SUBJECT: COMMENTS ON NUCLEAR ENERGY INSTITUTE 96-07, APPENDIX C:  
GUIDELINE FOR IMPLEMENTATION OF CHANGE CONTROL PROCESSES  
FOR NEW NUCLEAR POWER PLANTS LICENSED UNDER TITLE 10 OF THE  
CODE OF FEDERAL REGULATIONS, PART 52, REVISION 0C

**U.S. Nuclear Regulatory Commission**  
**Comments on NEI 96-07, Appendix C, Revision 0C**  
**Dated October 30, 2011**

**Figure 1 10 CFR Part 52 Change Process**

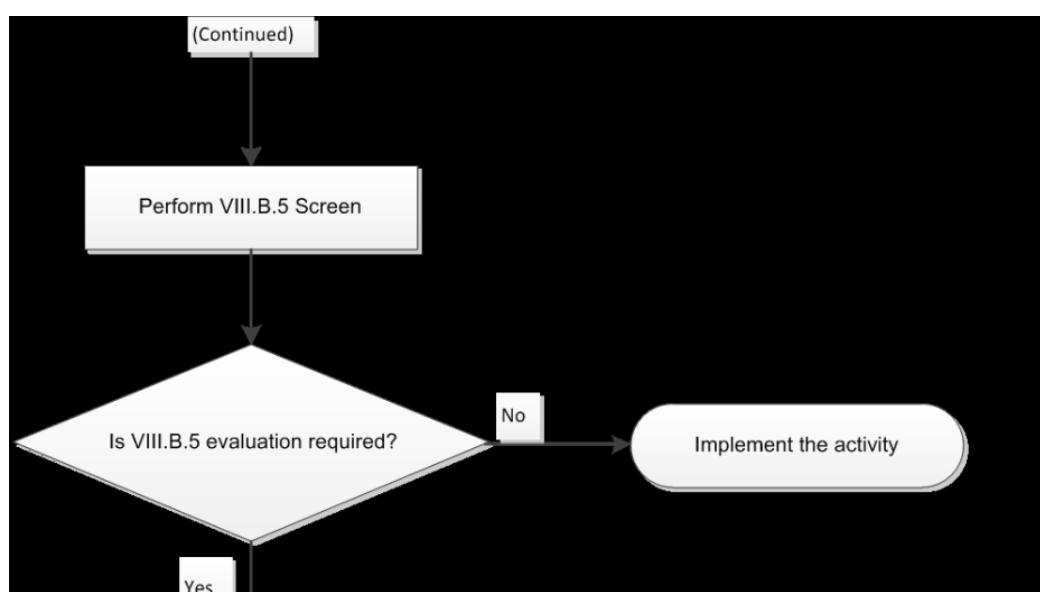
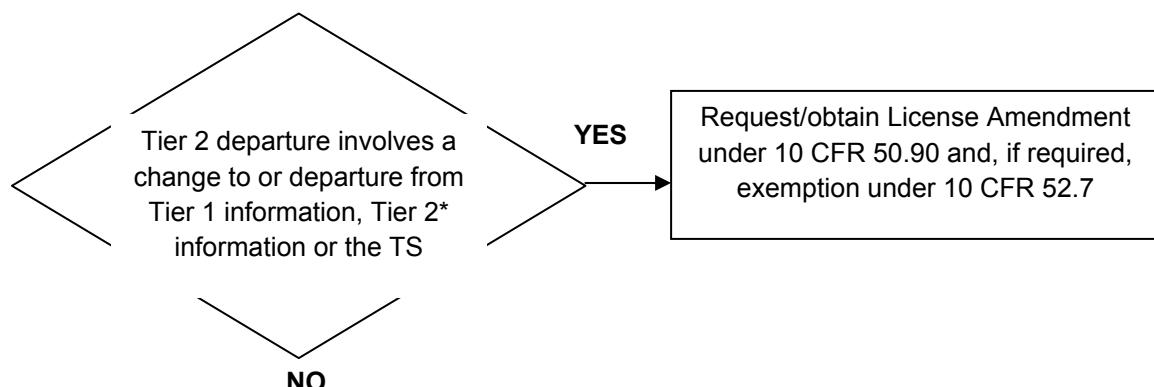
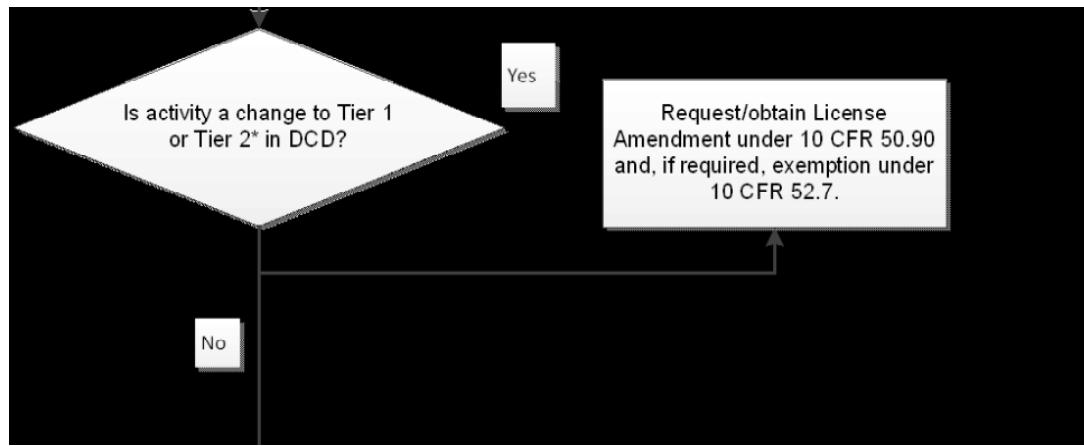
Add logic decision bi-stable diamond for evaluation of Tier 2 departure impact on Tier 1 and/or Tier 2\* information. A Tier 2 departure that involves a change to or departure from Tier 1 information, Tier 2\* information or the Technical Specifications requires a license amendment and the Tier 1 departure also requires an exemption from the design certification rule. (Section VIII.A.4, Section VIII.B.5.a, and Section VIII.B.6)

Is the activity related to site-specific FSAR information not within the scope of the **referenced plant-specific DCD?**

Following issuance of the COL, the FSAR contains the plant-specific design certification documentation. This plant-specific DCD information was derived from the referenced DCD. It is important to recognize the unique role the plant specific DCD plays in the safety analysis report and the change control regulations for the plant specific DCD information.
